SUBJECT: DAVIS-BESSE NUCLEAR POWER STATION, UNIT NO. 1 - ISSUANCE OF  
AMENDMENT RELATED TO STEAM GENERATOR INVENTORY CHANGE  
(TAC NO. MF0536)(L-13-040)

Amendment No. 287  
License No. NPF-3

SAFETY EVALUATION BY THE OFFICE OF NUCLEAR REACTOR REGULATION  
RELATED TO AMENDMENT NO. 287 TO FACILITY OPERATING LICENSE NO. NPF-3  
FIRSTENERGY NUCLEAR OPERATING COMPANY  
FIRSTENERGY NUCLEAR GENERATION CORP.  
DAVIS-BESSE NUCLEAR POWER STATION, UNIT NO. 1  
DOCKET NO. 50-346

Figure 3.7.18-1 (page 1 of 1)  
Maximum Allowable Steam Generator Level

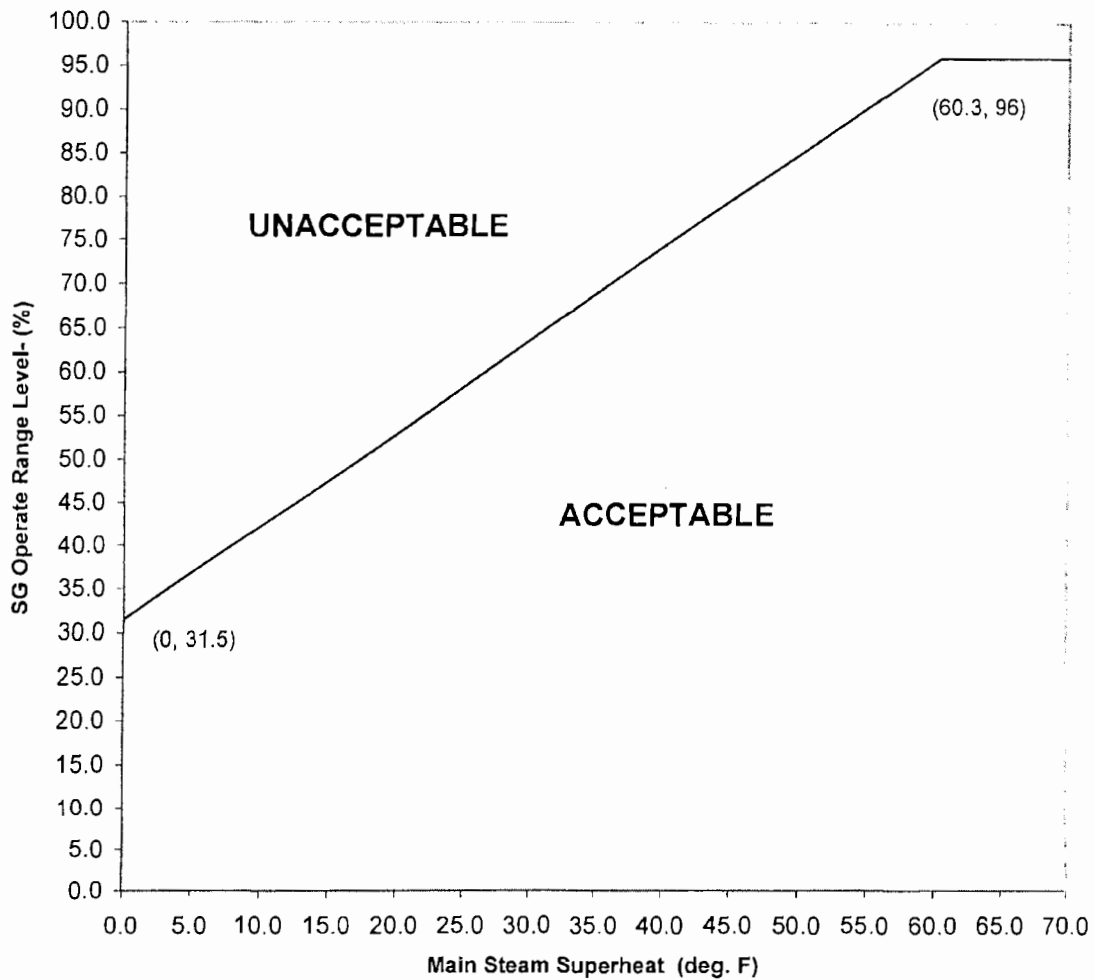
TS 3.7.18, "Steam Generator Level," establishes limit on SG level based on operating MODE and plant operating conditions. The four restrictions currently established in LCO 3.7.18 are based on the specific physical design characteristics and dimensions of the original SGs. Because of differences in design characteristics and dimensions of the replacement SGs, TS 3.7.18 would be revised to ensure appropriate secondary-side inventory limits are imposed. Specifically, LCO 3.7.18.a provides the maximum SG level allowed in MODE 1 or 2, by reference to TS Figure 3.7.18-1, "Maximum Allowable Steam Generator Level." Figure 3.7.18-1 identified acceptable Steam Generator Operate Range level indication (in percent) as a function of steam superheat [in degrees Fahrenheit (°F)]. Because of secondary-side dimensional and thermal performance differences between the original and replacement SGs, current TS Figure 3.7.18-1 is not appropriate for use with the replacement SGs and is to be replaced. Replacement Figure 3.7.18-1 was developed using the same

In its January 18, 2013, submittal, the licensee stated that TS Figure 3.7.18-1 provides a curve of SG level as a function of main steam superheat. The licensee stated that the proposed new curve, which reflects the dimensional characteristics and thermal performance differences of the new SGs, was obtained via the same methodology as the existing curve. The licensee also stated that given the proposed curve, the existing UFSAR MSLB analysis remains bounding.

To review the proposed change, the NRC staff requested additional information about the methodology used to develop the proposed, replacement curve, and verified that the licensee had correctly identified a complete set of licensing basis accident and transient analyses where the initial SG secondary inventory is a significant initial condition.

In its supplemental letter dated September 27, 2013, the licensee provided additional information about the methodology used to develop the new LCO curve. The licensee stated that the curve was developed using a computer code that solves for the steady-state conditions in once-through SGs. The code, VAGEN, predicts the steam superheat produced for a given SG mass inventory. The same computer code had been used for the previous curve; however, a newer version was used to develop the proposed curve. The licensee also stated that the newer version was validated using plant data, and that the validation indicated that the newer version more accurately simulated existing plant conditions than the previous.

Since the licensee used the same code to determine the proposed LCO as that used to determine the previous LCO, and since the updated version of VAGEN was validated and showed better agreement with plant data, the NRC staff determined that the LCO, which prescribes SG operate range level as a function of steam superheat, continues to ensure that the maximum SG liquid inventory assumed in the MSLB analyses is bounding of the design characteristics of the replacement SG. Based on this consideration, the NRC staff concluded that the proposed LCO is acceptable. Since the existing analysis remains bounding of plant operation with the new SGs, the NRC staff determined that the applicable design criteria, relating to adequate reactivity control, RCBP integrity, and adequate core cooling, remain satisfied in accordance with the current licensing basis.
